**The following changes in the bid documents are effective immediately. This addendum will form part of the contract documents.**

project / projet  
**ADDENDA A1  
 DID LAB  
 RENOVATION**  
 OTTAWA ONTARIO

## DID LAB RENOVATIONS

Date JANUARY 2019 ADD1-SKE4  
 Date

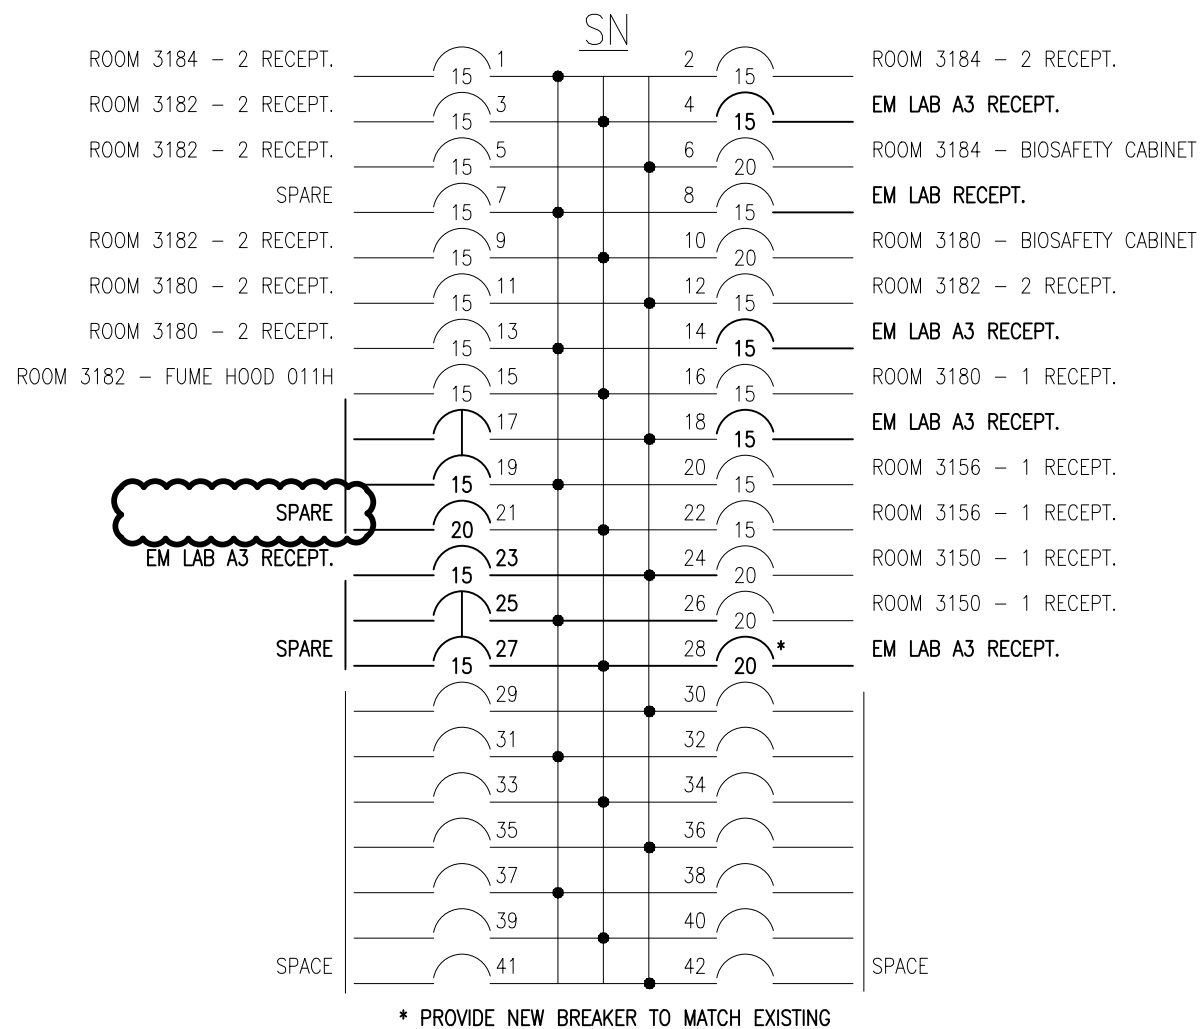
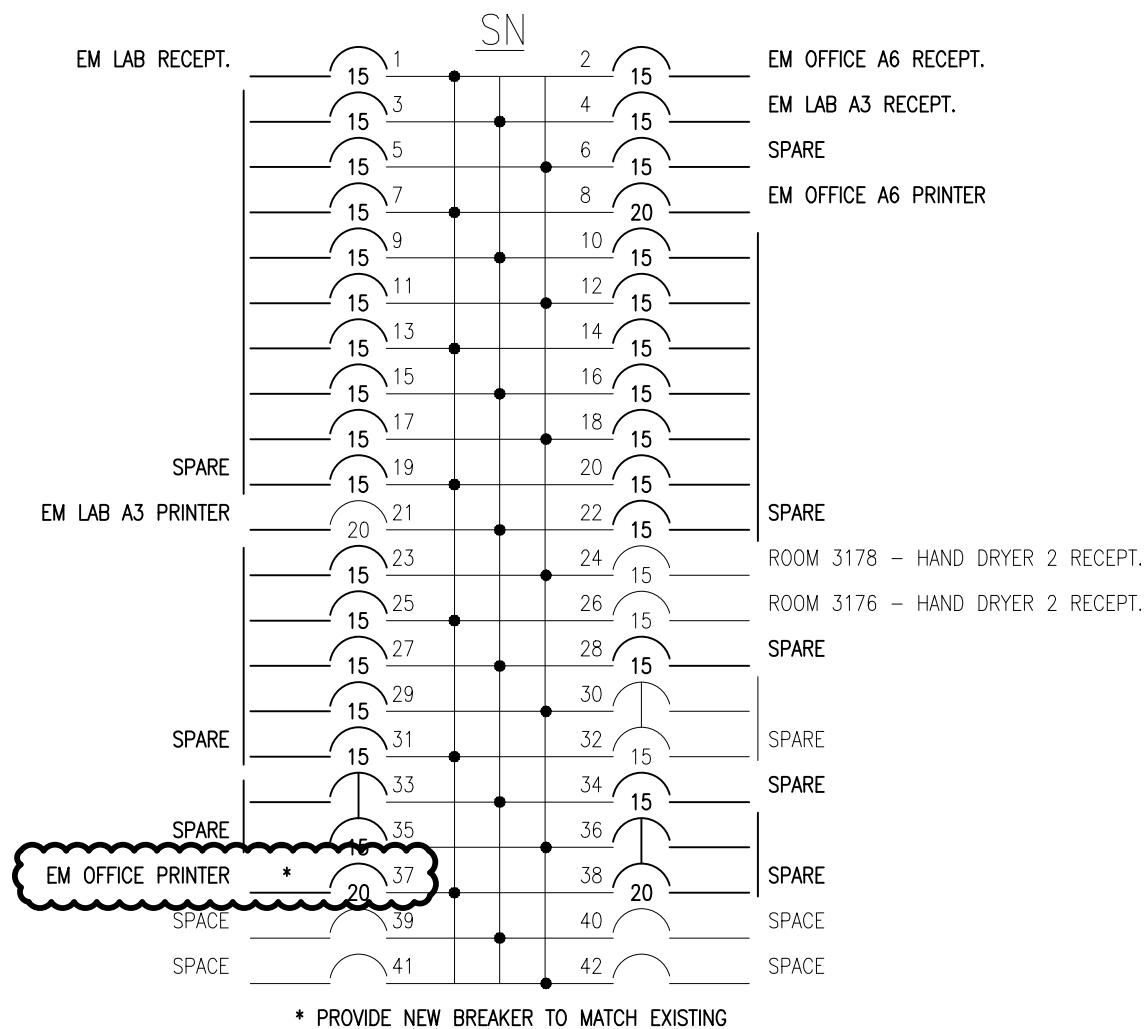
- .1 **DELETE** panel schedules for panels ‘132NPF’ and ‘132EPD’ and  
**REPLACE** with same panel schedules indicated on sketch ADD1-SKE4.
